PIC18C658/858 Rev. C3 Silicon/Data Sheet Errata

The PIC18C658/858 parts you have received conform functionally to the Device Data Sheet (DS30475A), except for the anomalies described below.

Clarifications/Corrections to the Data Sheet:

FIGURE 1: INTERRUPT LOGIC (EXCERPT)

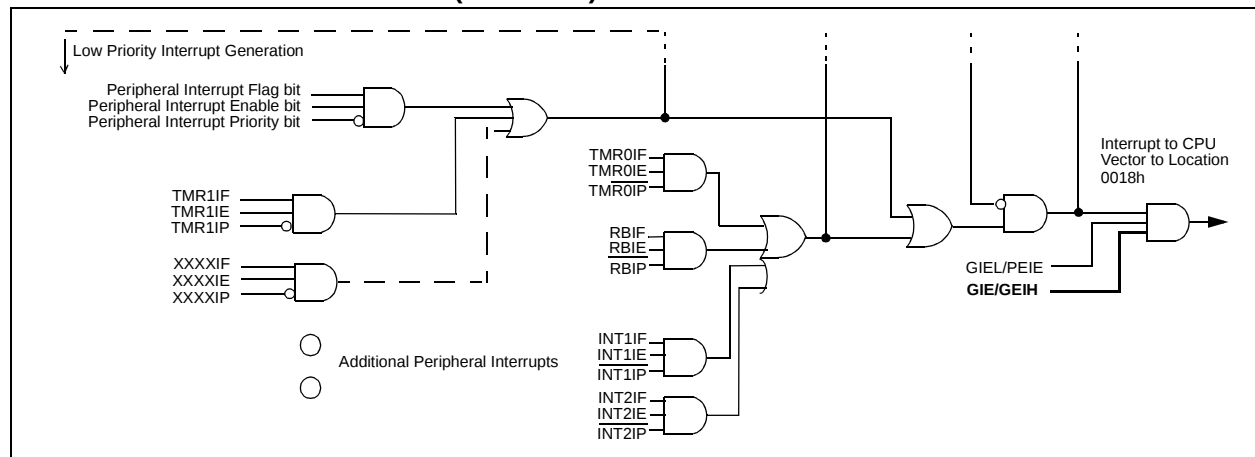
The operation of the GIE/GIEH bit (INTCON<7>) is clarified as follows: when the bit is cleared, all interrupts are disabled. This is regardless of the state of the IPEN bit (RCON<7>), the priority of the interrupt, or whether or not the interrupt is unmasked. This varies from the original description, in which clearing the bit when IPEN = 1 would only disable high priority interrupts.

Also, the interrupt logic funnel shown in Figure 7-1 of the Device Data Sheet is amended with the addition of a GIE/GIEH control line, as shown in Figure 1 (new material in **bold line**).

“It is important to note, however, that clearing the GIE/GIEH bit, regardless of the state of the IPEN bit, will disable **all** interrupts.”

bit 7	GIE/GIEH: Global Interrupt Enable bit
<u>When IPEN (RCON<7>) = 0:</u>	
1	= Enables all unmasked interrupts
0	= Disables all interrupts
<u>When IPEN (RCON<7>) = 1:</u>	
1	= Enables all high priority interrupts
0	= Disables all interrupts

FIGURE 25-1: PIC18CXX8 VOLTAGE-FREQUENCY GRAPH (INDUSTRIAL, EXTENDED)

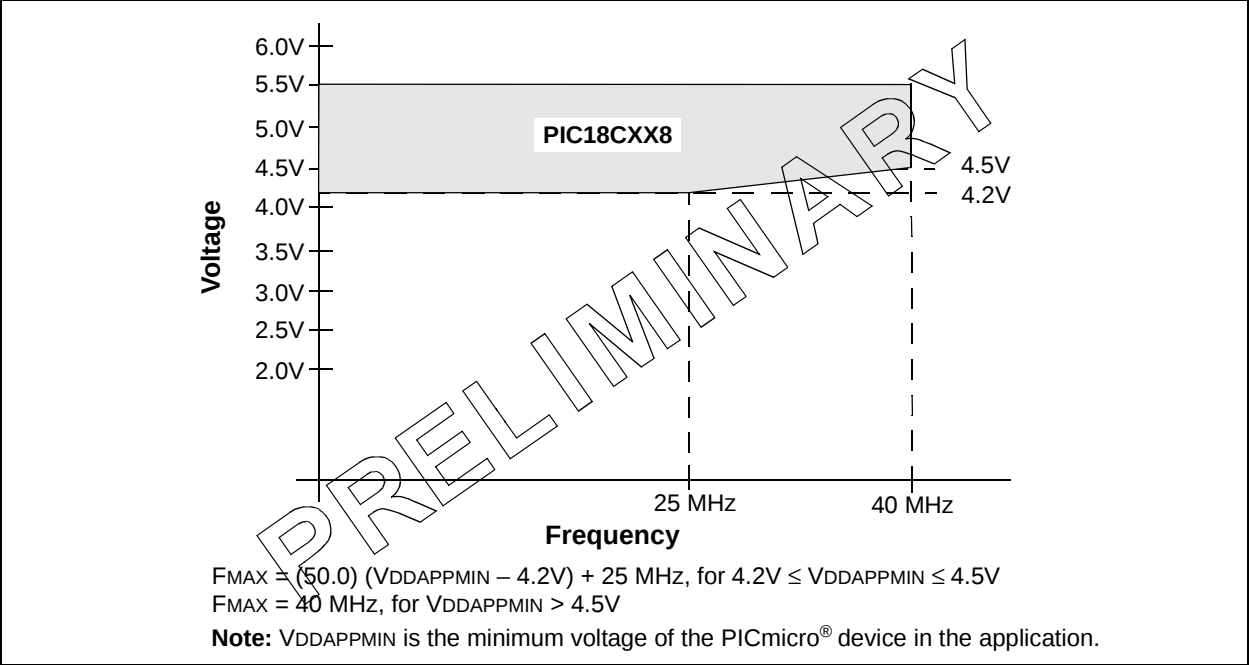
The operating frequency range has been updated.

The maximum frequency for an external clock is clarified as 200 kHz in LP mode, and 4 MHz in XT mode. For all Oscillator modes, parameters 1 and 1A are also clarified as being applicable to both industrial and extended temperature range devices.

The maximum external clock frequency (EC and ECIO modes) and oscillator frequency (HS mode) remains at 40 MHz, as originally reported in the Device Data Sheet (DS30475A). Also, the maximum clock and oscillator frequency for HS+PLL mode remains at 10 MHz. This supersedes the more conservative values reported for earlier silicon revisions. Other values of the related clock period parameters are updated accordingly.

The voltage vs. frequency graphs have also been updated. Figures 25-1 and 25-2 of the Device Data Sheet are replaced with the graphs shown on the following page.
